Re: **PETITION NO. 1189** – The United Illuminating Company Petition for a Declaratory Ruling that no Certificate of Environmental Compatibility and Public Need is Required for the Proposed Modifications to the Existing Mix Avenue Substation Located at 690 Mix Avenue, Hamden, Connecticut and Related Improvements to Existing Electric Transmission Line Circuits from Mix Avenue Substation to Glen Lake Junction and from June Street Substation to Pease Road

Several drawings The United Illuminating Company (“UI”) submitted with the above captioned Petition for modifications to the existing Mix Avenue substation depicted installing a concave perimeter fence in the northwest portion of the substation yard. However, UI plans to modify the fence line as shown on the attached drawing in order to provide improved accessibility to and within the substation yard. I submit the revised drawings for your review.

ELECTRICAL SITE PLAN CAPACITOR - REACTOR ADDITION			
				MIX AVENUE SUBSTATION			
1	2/2016	CAPACITOR BANK AND REACTOR ADDITION	TDP	-	BLH	MAV	Drawn
No	Date	Revision	By	Chkd.	Engr.	Supr.	Chkd.
			Date		Scale: 1/16"=1'-0"		CAD FILE NAME
			Design Engr.		Design Supv.		SEQUENCE No.
							DRAW

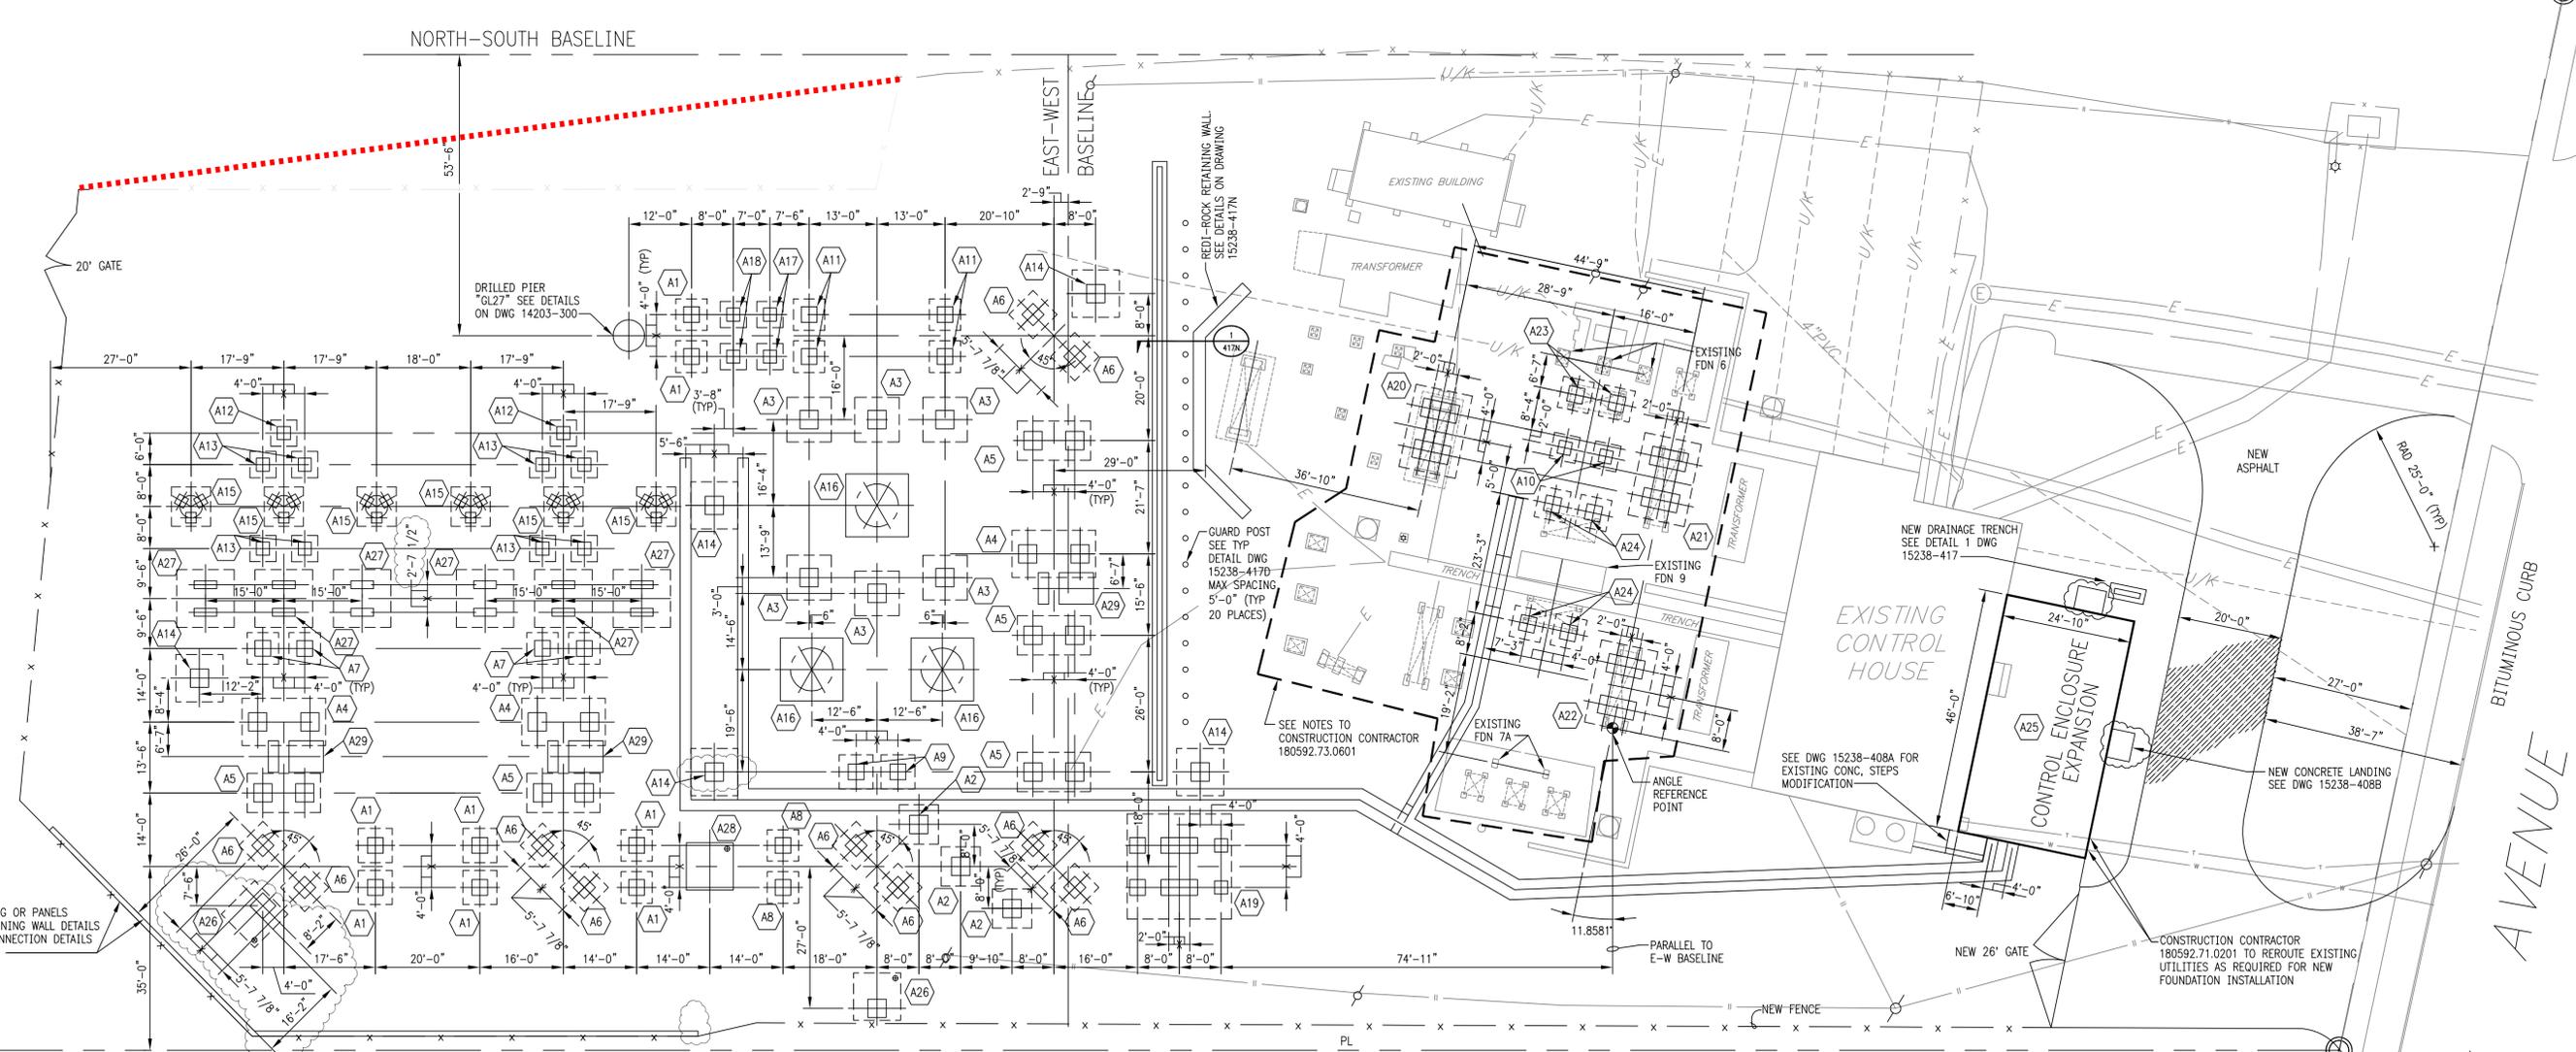
BACKCIRCLED CHANGES PER ECN-180592-0006
